Detroit Edison
2000 Second Avenue
Detroit, Michigan 48226
(313) 237-8000

June 17, 1985

Subject: Proposed Permit for Reissuance
NPDES Permit No. MI 0001848
Monroe Power Plant

Attachment 2

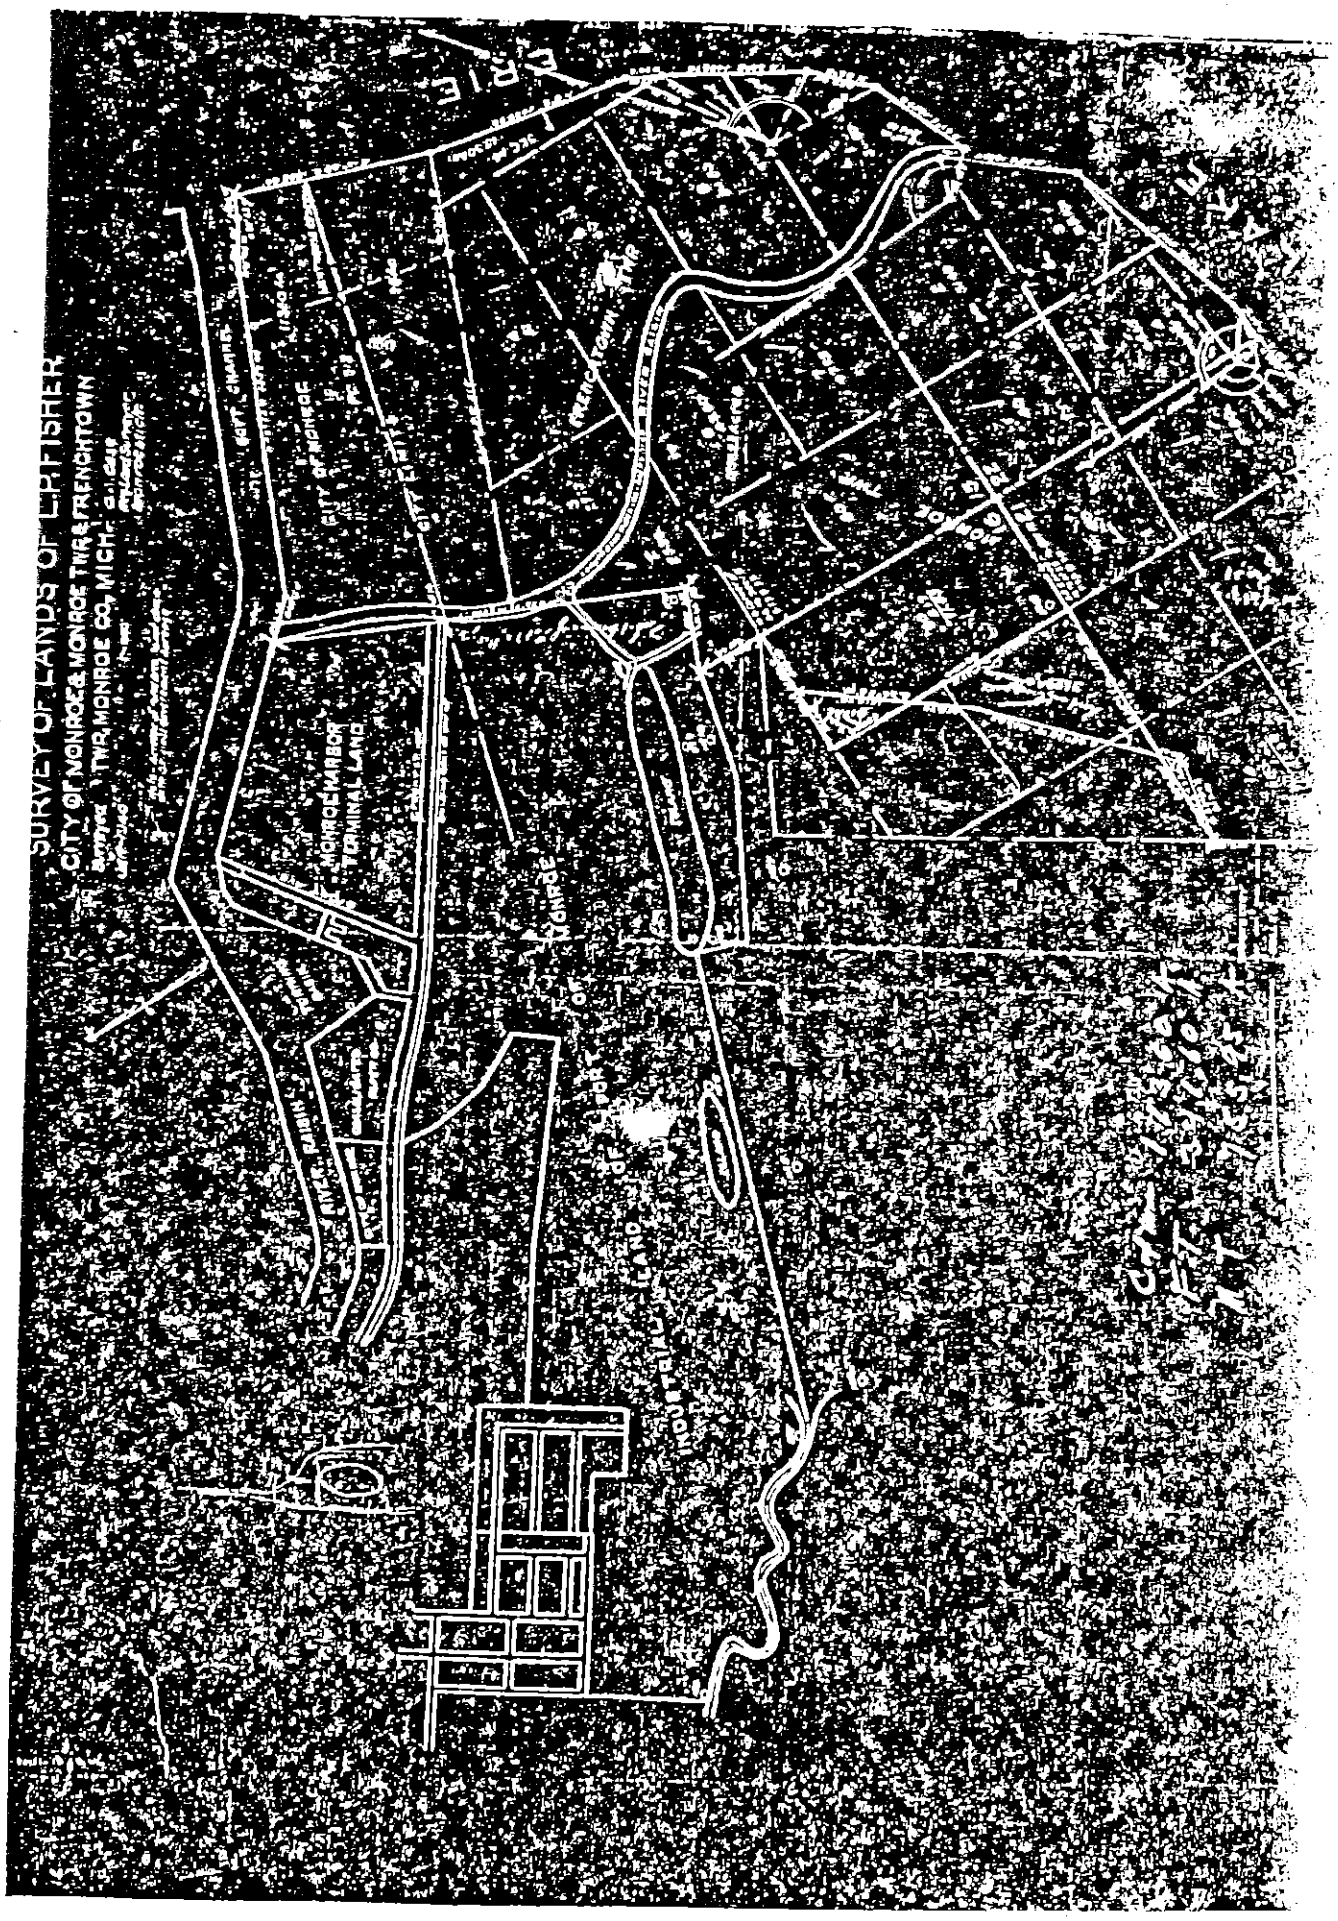
b) A land survey map, dated 1940, prepared by O.A. Case, Registered Land Surveyor, which also identifies the "Government Channel" and the natural flow path (the old channel) of the Raisin River. (Attachment 2)*

The Company, therefore, requests that all references to "Plum Creek" be deleted from the draft permit.
